Tanzila New building, extension

Baroypara, Ashulia, Savar, Dhaka

12th March 2018

5th floor carton storage area

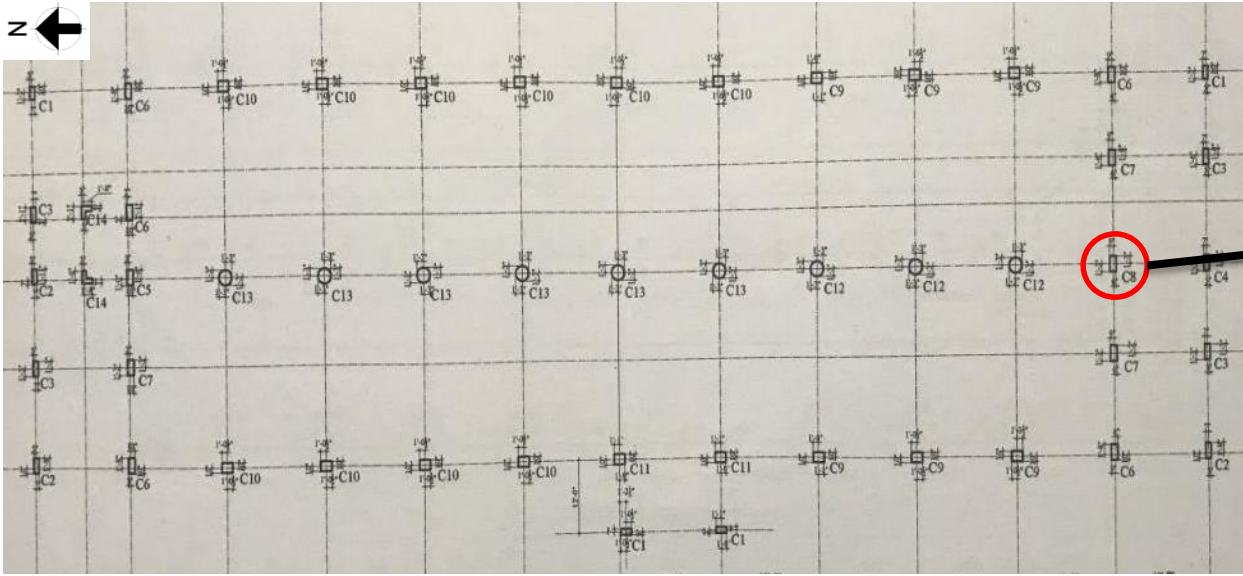
Load was measured below 3Kpa on every floor and FoS calculation for columns were found satisfactory. For 5kPa column stresses exceed normal design limit.

Factory is required to maintain the floor live load 3 kPa until further verification by design engineer.

C-8 type column

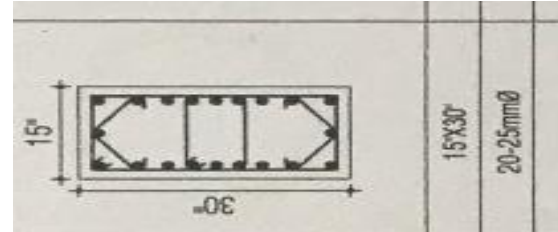
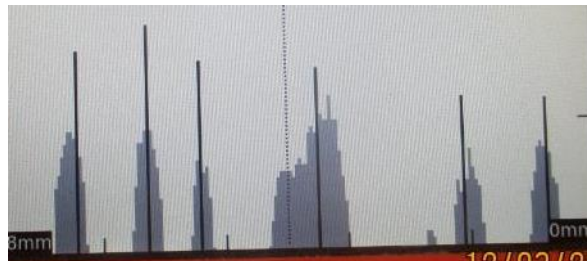
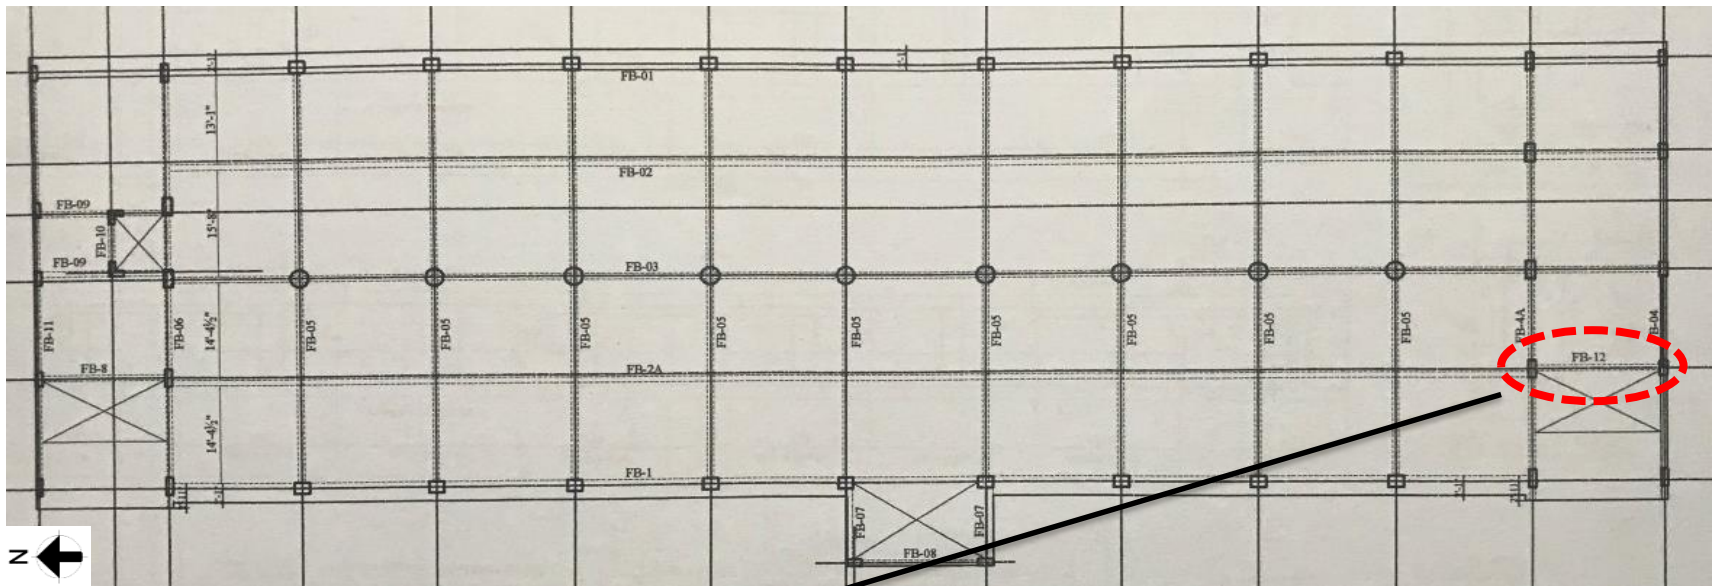
16 nos. rebar were found by ferro scanning in C-8 type column

20 nos. rebar were shown in column schedule for C-8 type column in ground floor

20 nos. rebars were shown on the drawing in C-8 type column but during inspection 16 rebars were found by ferro scanning in ground floor.

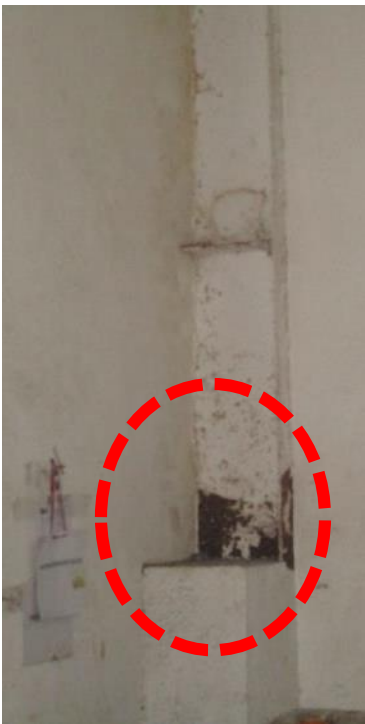
No vertical bracing or compression strut was observed on 1st floor. Only vertical bracing was observed in ground floor.

Factory could not provide any structural document of the shed. Factory Engineer is required to produce a full set of as-built drawing reflecting actual condition. Lateral stability of the shed need to verified against lateral loading.
